INDESIT company

Model type:
WM12XUK

Commercial code:
F027231

FIG. 1

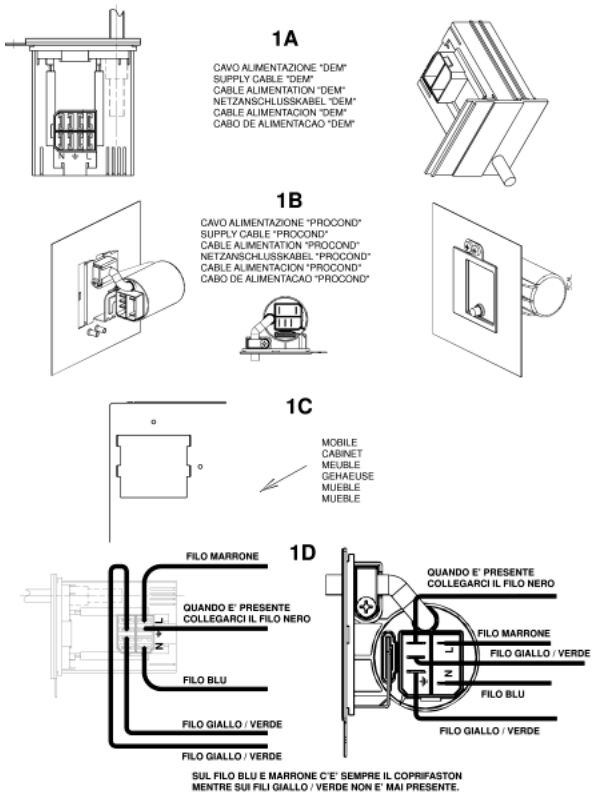
All appliances produced in the Comunanza (from serial no. 21008.0001), Teverola (from serial no. 21111.0001) and Brembate (from serial no. 21119.0001) factories have been equipped with power supply cables with integrally moulded filter (see fig.1 - 1A and 1B) and new units having a specific opening at the back for fixing the new cables (see fig. 1 - 1C).
The new units, together with the new cables, can be used in place of the premodification ones, by connecting the wiring to the cable, as shown in figure 1 - 1D.
The codes of the new units and of those replaced (ESI - table n1040276fig02), which will be managed until stocks run out, are given below.

The premodification wirings, are also managed for modified products by making the connection to the terminal block of the new cable as shown in fig. 1 - 1D.
The wiring diagrams given in the Documentation remain unchanged.

The new power supply cables are:
Code 091632 - Power supply cable 3x1 schuko 1.5m+capacitance filter;
Code 091633 - Power supply cable 3x1 schuko 1.5m+inductive filter;
Code 091634 - Power supply cable UK 3x1 l= 1950mm + inductive filter;
Code 091635 - Power supply cable UK 3x1 l=1950mm+capacitance filter;
Code 091636 - Power supply cable l=2.55m AUS+inductive filter;
Code 091641 - Power supply cable l=2550mm AG +capacitance filter;
Code 091642 - Power supply cable 1.85mt SHUKO no inductive filter;
Code 091643 - Power supply cable 3x1 (CH) 1.5m+inductive filter;
Code 091645 - Power supply cable 3450mm SOUTH AF.+capacitance filter;
Code 091690 - Power supply cable shuko l2.55m KOREA+inductive filter;
Code 091689 - Power Supply cable l=2550mm AG+inductive filter.

IMPORTANT: the fixing / continuity screw is a specific self-scraping screw (code 092348) that ensures earth continuity between the filter and the unit. The same screw must be refitted in order to guarantee machine conformity.

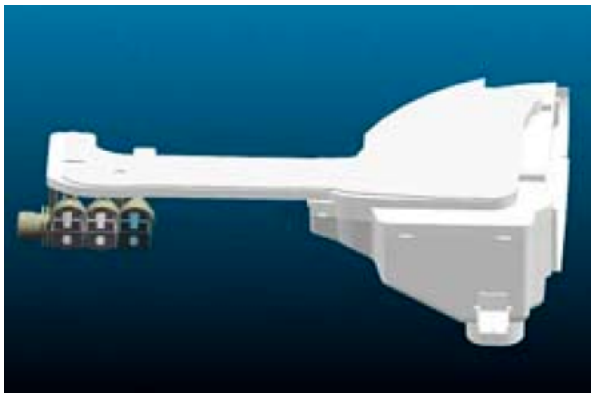
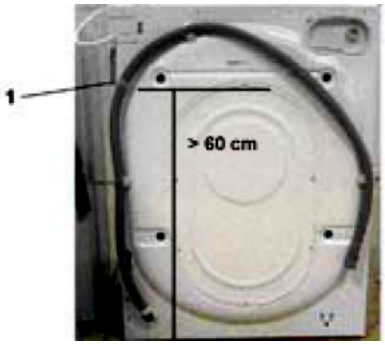
From serial number 21219.0001, the new "OKO" drainage system has been introduced on the washing machines produced in the Comunanza factory.

- EEPROM (the OKO system requires a new setting of load timing parameters). THE NEW EEPROMS REPLACE ALL THE ONES CODED PREVIOUSLY.
- BOWL (hopper tube hole shifted forwards);
- DETERGENT LOADING TUBE (see fig. 1);
- PRESSURE SWITCH (changed levels);
- OKO PUMP BOWL BLOWER + BALL (see fig. 2A, 2B and 2C);
- CONDUCTIVITY SENSOR (if provided, it is shorter than the premodification item);
- DRAIN PUMP (without detergent collecting tube connection);
- HOPPER (shifted in front of detergent loading tube connection). Fig. 3A post-modification. Fig. 3B premodification);
- AIR TRAP (different shape);
- PRESSURE SWITCH TUBE (different length);
- DRAIN TUBE STOP (specific);

In particular, the OKO system consists of a spherical plastic component inserted in the tube that connects the bowl to the drain pump (see fig.2 A).
At the beginning of each wash cycle the washing machine fills water for 10 seconds and activates the drain pump for 2 seconds. In this way, the water level in the bowl is different from that in the drain tube; this difference increases the thrust of the ball upwards, closing the bowl-pump connection tube hermetically (see fig. 2D).
This system has the double advantage of:

1) separating the wash water and the water in the drain hose, thus saving energy during the heating phase;
2) and ensuring optimal use of all the detergent.
With the introduction of this new component, the detergent collecting tube is no longer required and the pump has one hole only to convey water from the tank.
For the correct operation of the OKO system, it is important that the drain hose of the washing machine remains fixed to the back of the unit with a plastic clamp (to this end, the clamp withstands a 25 kg load; see reference 1 in fig. 4); otherwise, the drain hose must absolutely reach the height of the clamp. (minimum 60 cm.)

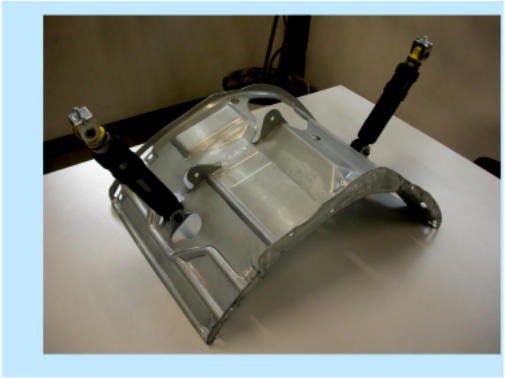
From serial no. 40427.0001, shock absorbers have been fixed to the tank unit cradle with two 11 mm pins code C00110163 (see fig. 01 and 02 enclosed) in place of the 8 mm screws code 093750 and relevant locking nuts code 030443, on all washing machines and dryers produced in the Comunanza factory.
The items affected by this modification are:

1) The cradles have the same Service code, as they can be used in place of the new ones after widening the shock absorber fixing holes to a diameter of 10 mm.
Code 093848 - Tank unit cradle 46 lt
Code 093878 - Tank unit cradle 40 lt.

2) The new shock absorbers, with fixing bushing having no s/steel spacer, are not managed as they are interchangeable with the premodified items (make sure they are CIMA type, as the managed items), fixed with M8 screws code 093750 and related locking nut code 030443 (see figs. 05 and 06).
Code 093884 - Shock absorber 80 N
Code 093885 - Shock absorber 100 N

To remove the shock absorber from the tank, first extract the pin with a few hammer taps (see fig.03) until it is aligned with the tank bracket and then pull it out with a pair of pliers (see fig. 04).
(To refit the shock absorber use a new pin. Insert the pin until the toroidal edge is aligned with the bracket.)

Fig . 001

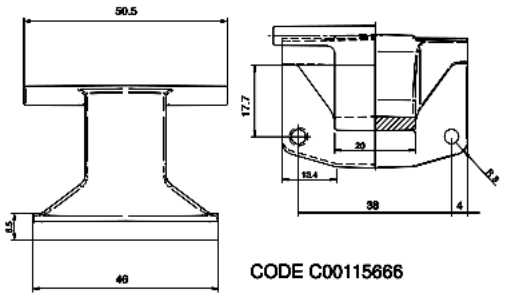
From serial no. 50207.0001, all Ariston models produced in the Teverola factory (see table 001 attached) with industrial code (given on the rating plate) starting with 46, have been equipped with a Zamac hinge with 150° opening angle, code C00115666

(see Fig.001).
This modification has involved the introduction of the following items:

Code C00115670 - Complete door EVOII 150° white 27 with standard glass;
Code C00115674 - Complete door EVOII 150° white 27 with long glass;
Code C00115667 - EVOII body for 150° hinge white 27;

The premodified items are not interchangeable separately with the modified ones.
